Subject: Submission for Proposed Development 17A Woodbine St North Balgowlah

Please find below our concerns for the proposed demolition and construction of a dwelling house at Lot B DP 400573 - 17A Woodbine Street North Balgowlah.

Application number: DA2019/1026.

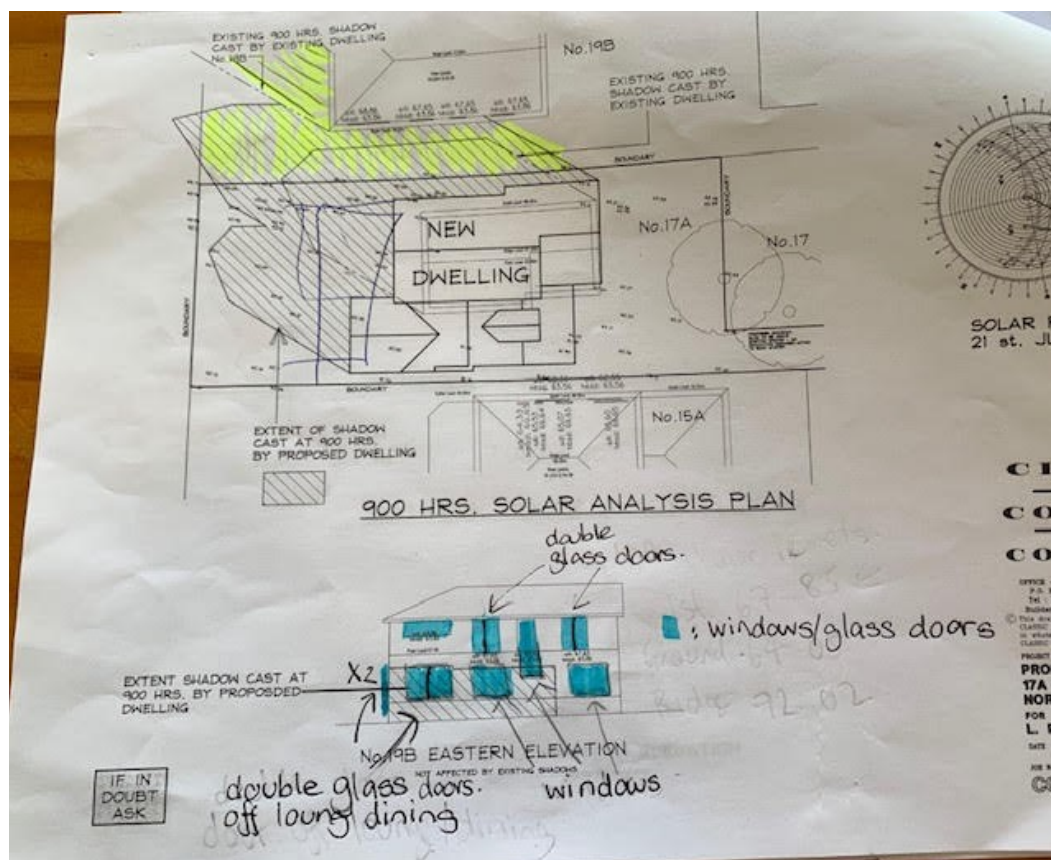
Looking at the Western Elevation of the proposed dwelling with a ridge level of RL70.0, we are concerned that we will lose our views out towards Manly and the ocean. We have two Juliet balconies with glass doors and a big window that starts on the ground level up to the roof of the first floor to capture the view, and a window in the master bedroom. This view can be seen from all first-floor windows and doors on the eastern side of our house. We are also concerned that the proposed first-floor deck at the front of the proposed dwelling will also impact on our views as this has a large privacy screen. The loss of this view will impact our lifestyle and decrease the value of our house. We request that the height of the proposed dwelling at 17A be reduced so we maintain these views.

Our house (19B) eastern elevation in the shadow diagrams does not show any windows or glass doors on the ground floor. This indicates that we will not be affected by the shadow cast which is inaccurate. One of the windows on the first floor also extends down to the ground floor. This undermines the effect of the proposed shadow cast which will impact the whole eastern side and most of the southern side of our house where the main outdoor living areas are located including our swimming pool, spa and children recreation areas (please refer to the attached photo). We request that the bulk of the proposed dwelling at 17A be reduced so we retain morning sunlight on the eastern and southern sides of our house.

The proposed dwelling has a first-floor deck at the rear of the dwelling. This will be on a level close to that of our first floor and we are concerned that we will lose our privacy in both the master and another bedroom on our first floor. The three first floor windows (W21, W20, W19) of the proposed dwelling will also impact on our privacy. We request that these be moved to an area directly across from wall spaces on the eastern side of our house. We are concerned that these windows will be located across from our master bedroom window and the other bedroom glass doors.
